BEACON PLANNING BOARD
Via Video-Conference
BEACON, NEW YORK 12508
Phone (845) 838-5002 Fax (845) 838-5026

City of Beacon Planning Board
5/12/2020

3 Water Street

Public hearing on application for Site Plan Approval (relative to a Special Use Permit), Accessory Apartment, 3 Water Street, submitted by POK Beacon, LLC

JOB #: 2020:013
 DATE: 3/31/2020
 SCALE: 1" = 20'
 TITLE: GD-1
 SHEET: 3 OF 6

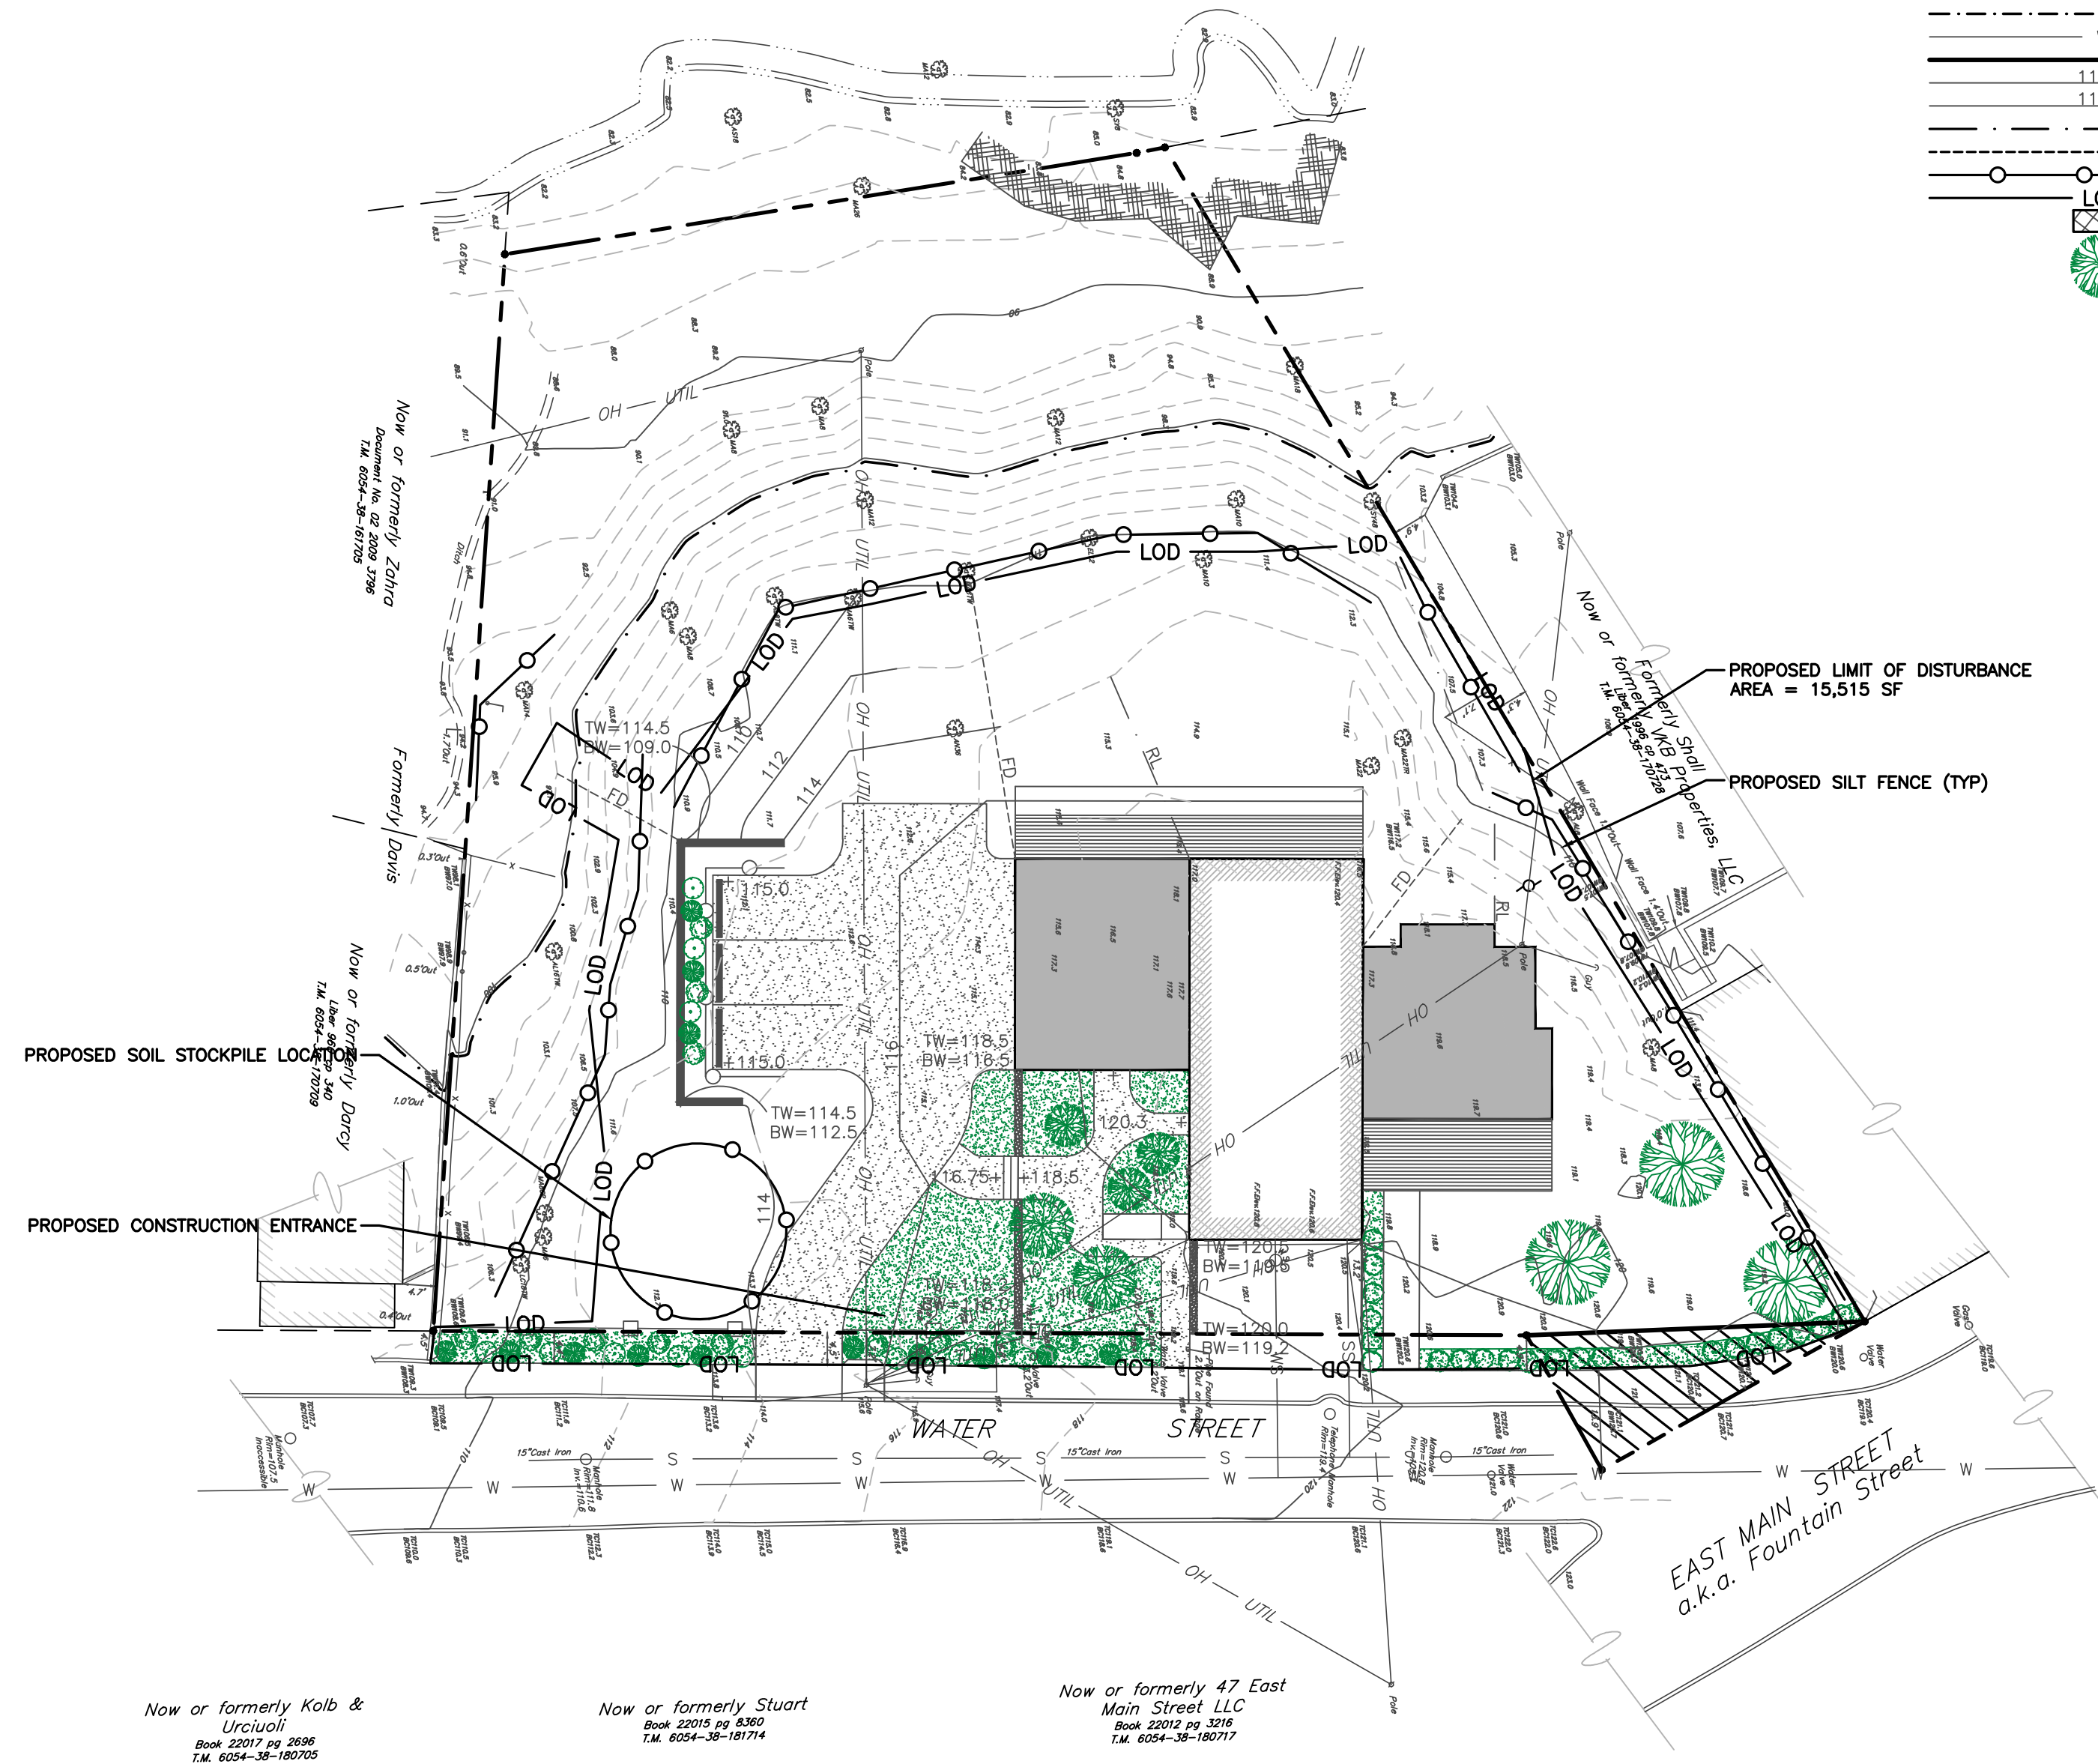
Grading & Utility Plan (Sheet 3 of 6)

1. The grading was not necessary in that area and was only shown to provide a uniform slope over the existing slope. Therefore, the grading has been removed and the wall elevations have been adjusted.

2. The existing water and sewer service locations and sizes are now shown on the plans.
3. The driveway has been re-configured to avoid the pole and guy wire.

6. The hatching has been scaled back so that the elevation labels can be seen with more clarity.
7. The water line is now labeled as 6" on the plans.
8. There is no grading proposed at the north side of the accessory apartment. The existing slope will be left undisturbed to the greatest extent possible.

| PROJECT NUMBER | PROJECT MANAGER | J.J.C. | DRAWING NO. | SHEET |
|----------------|-----------------|--------|-------------|-------|
| 19131.100 | J.F.R. | J.F.R. | SP-1 | 3 |

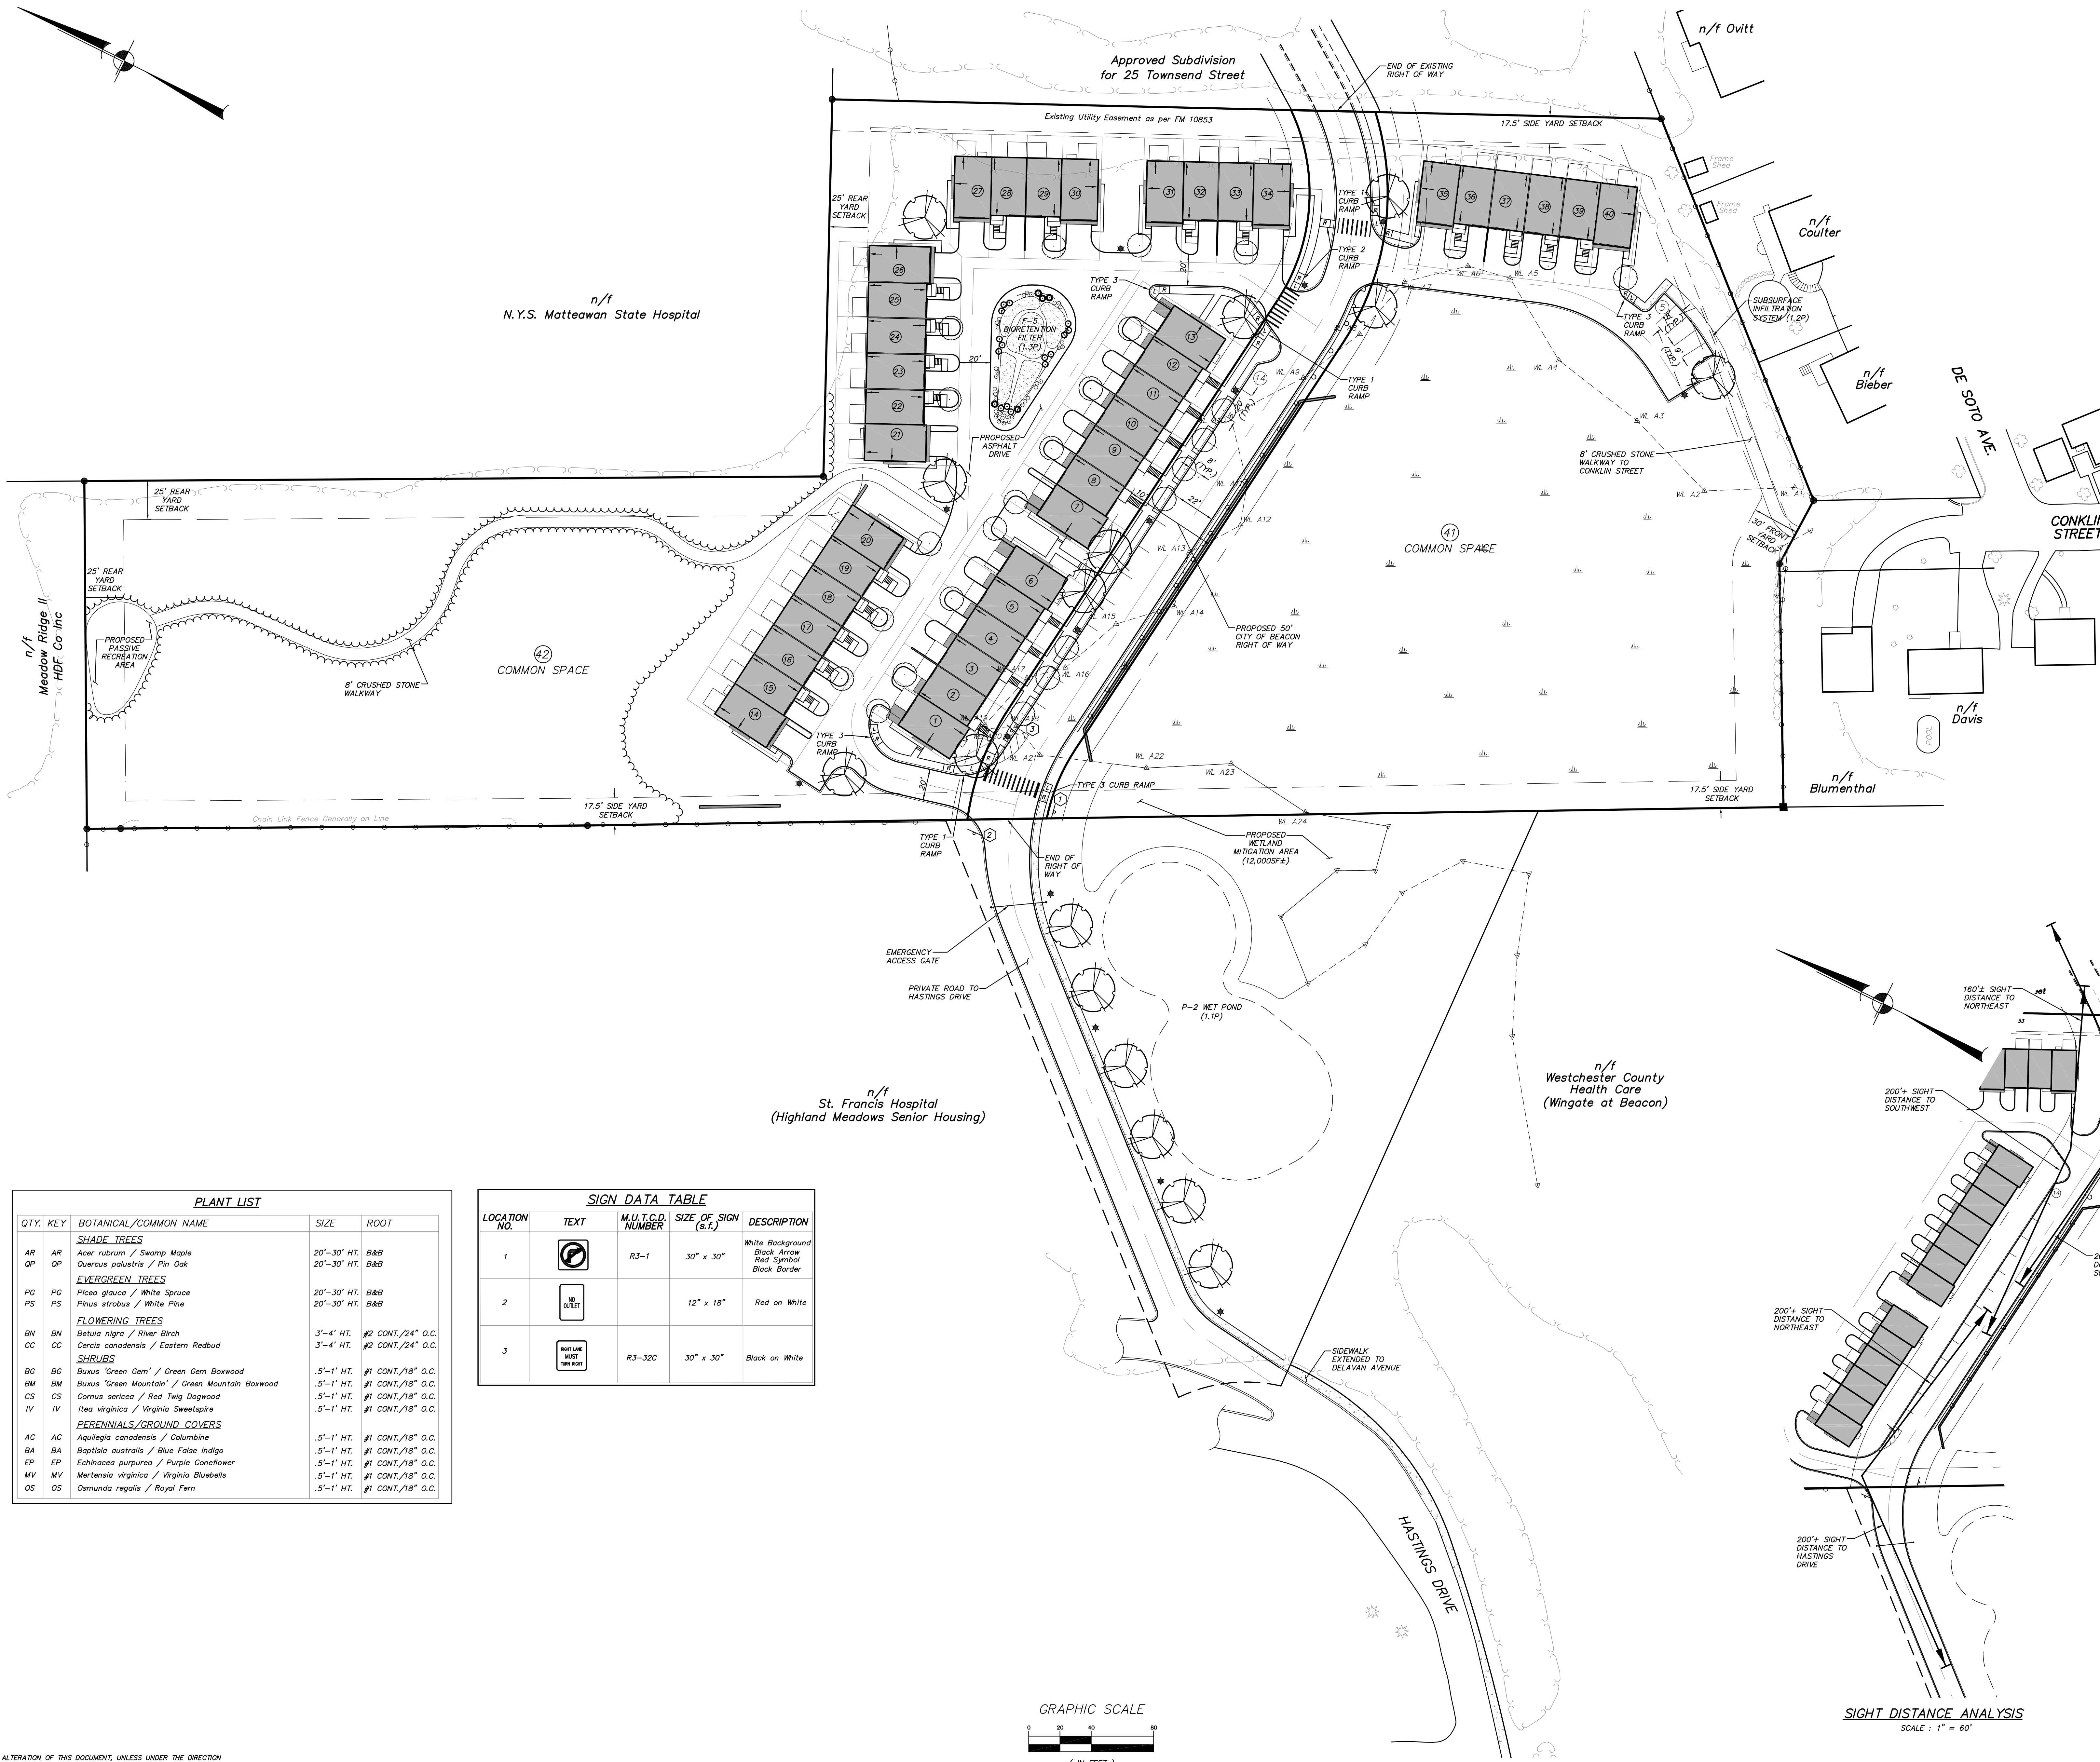
1. For the Sheet SP-1 Layout and Landscape Plan:
 - a. In the Zone Requirements table, the minimum side yard should be 17.5 feet or half the height of the permitted building in the RD-5 district.

| FIGURE: | FIG - 4 |

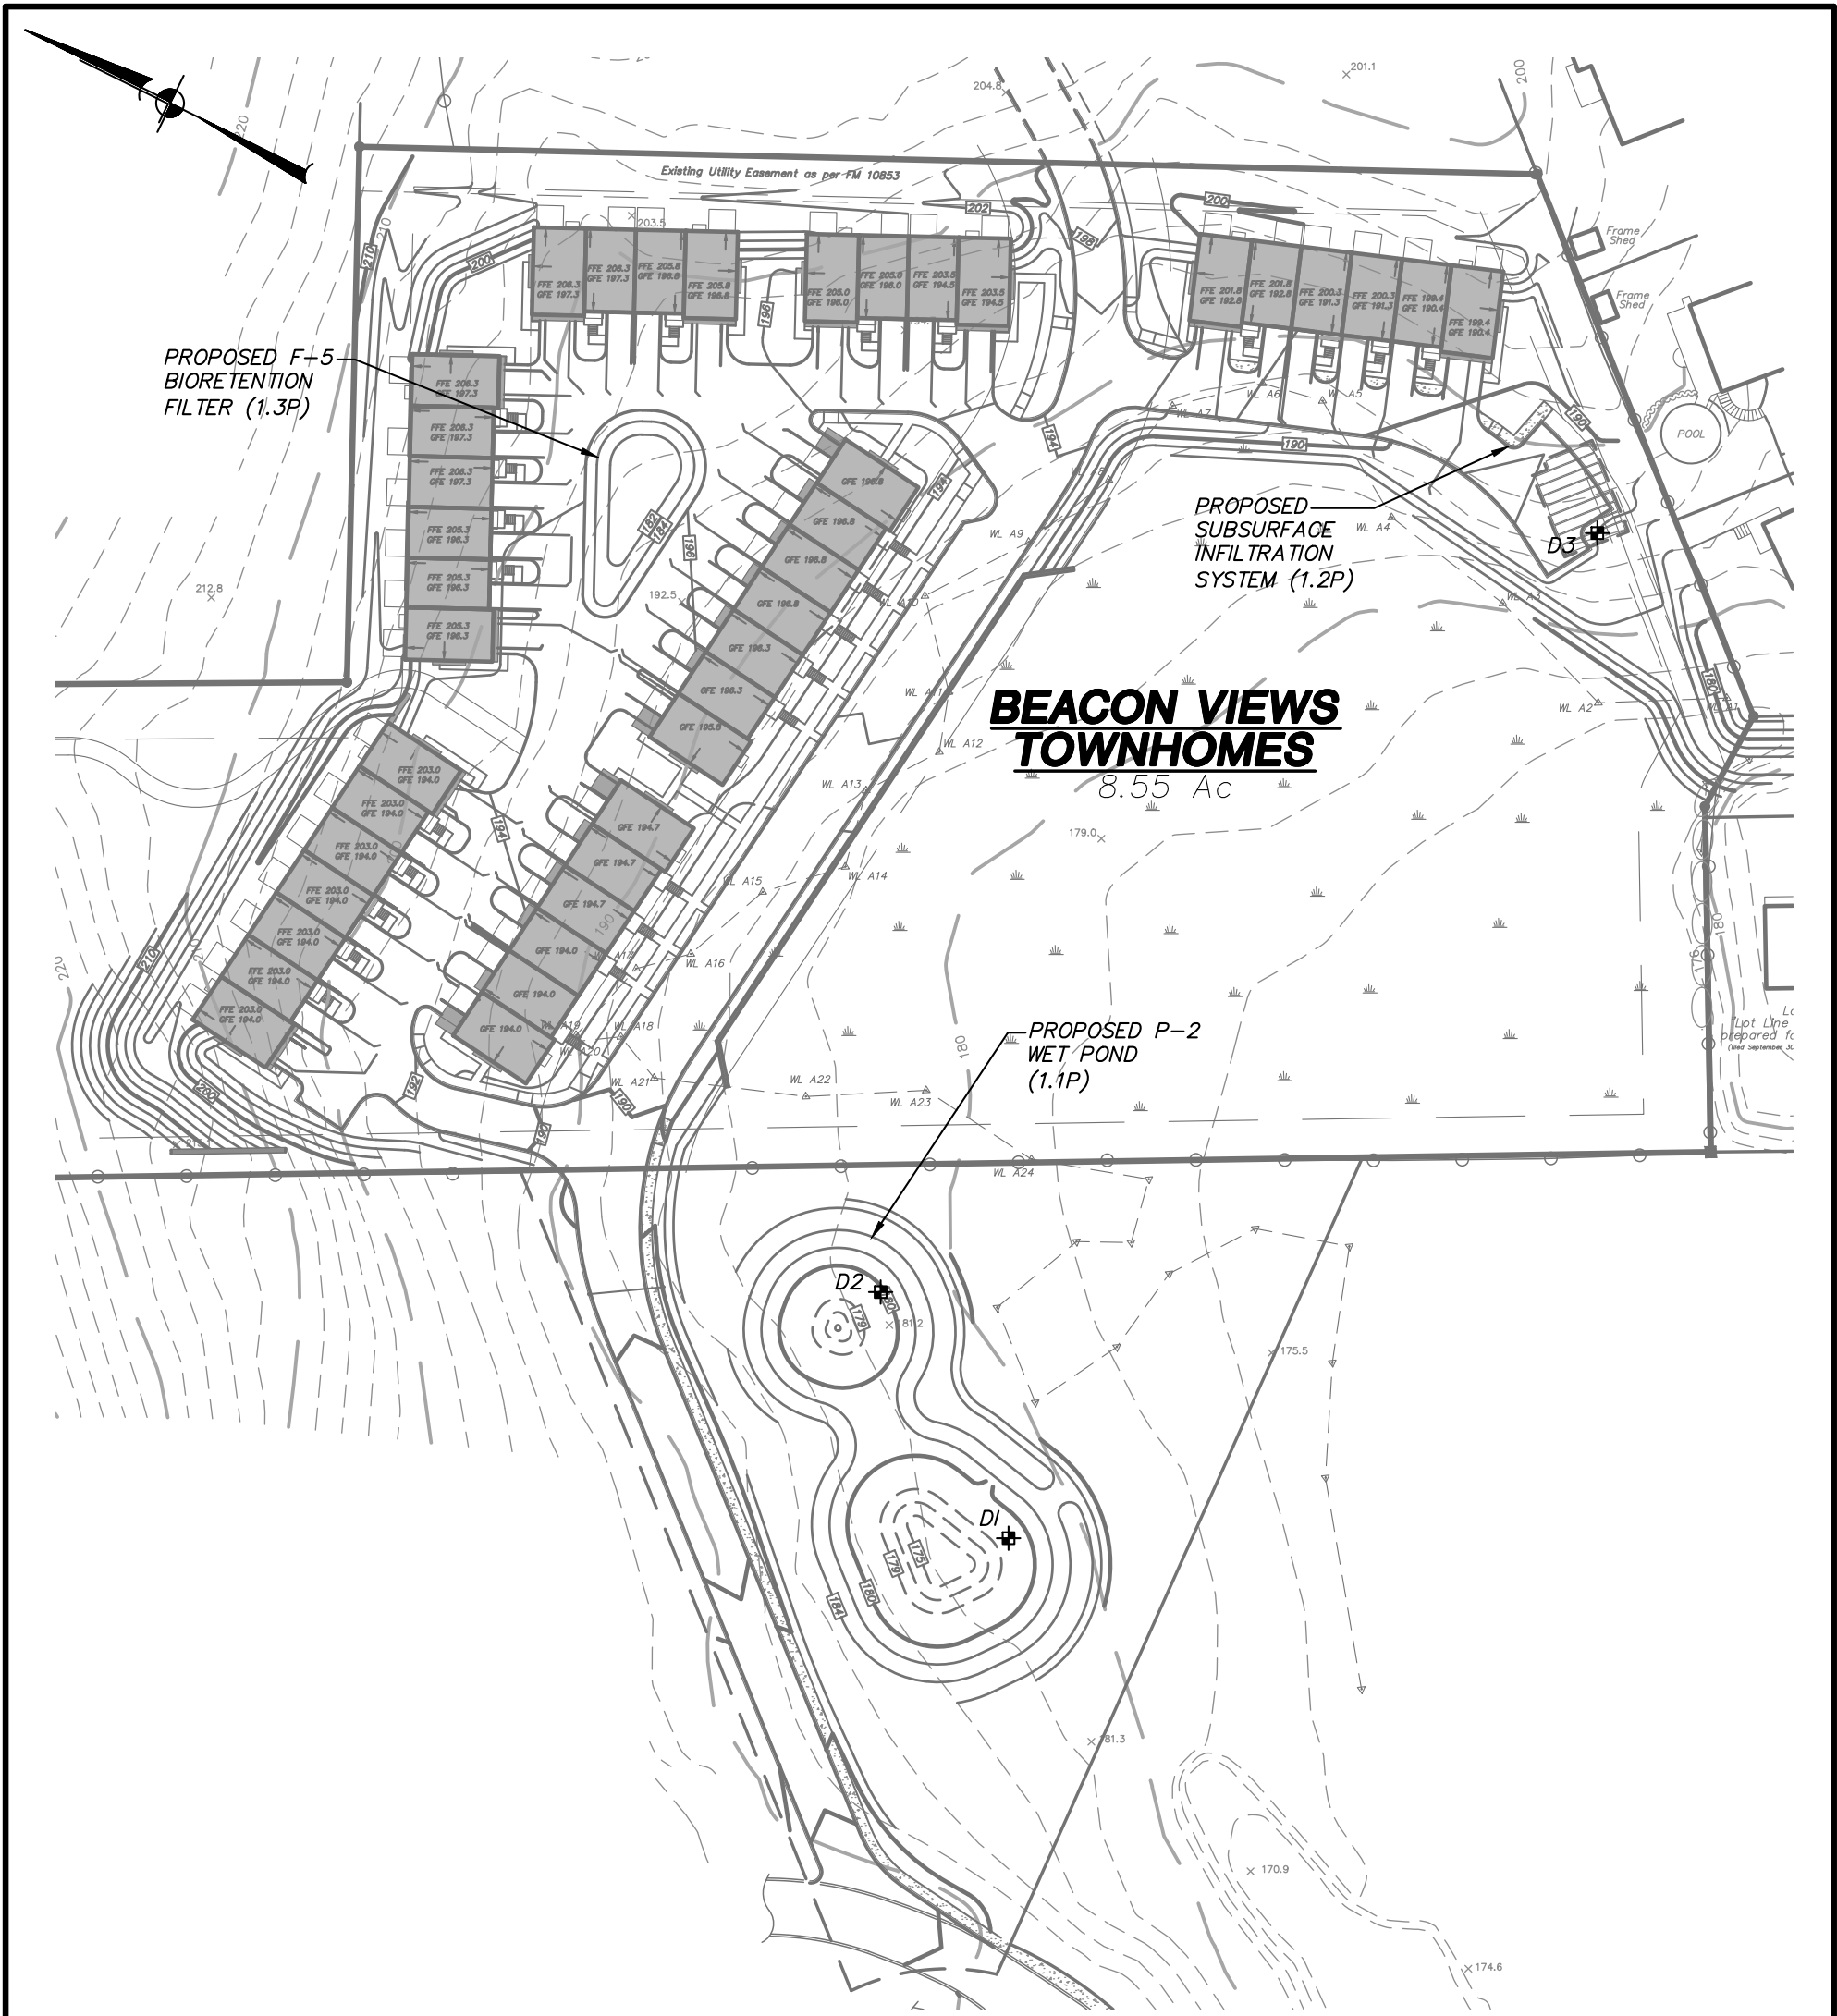
12. Reaches should be shown and labeled on the post-dev map.
13. Figure 4 shows a deep test result for D-2 as 2"-8"+ but then states ground water at 18", please clarify
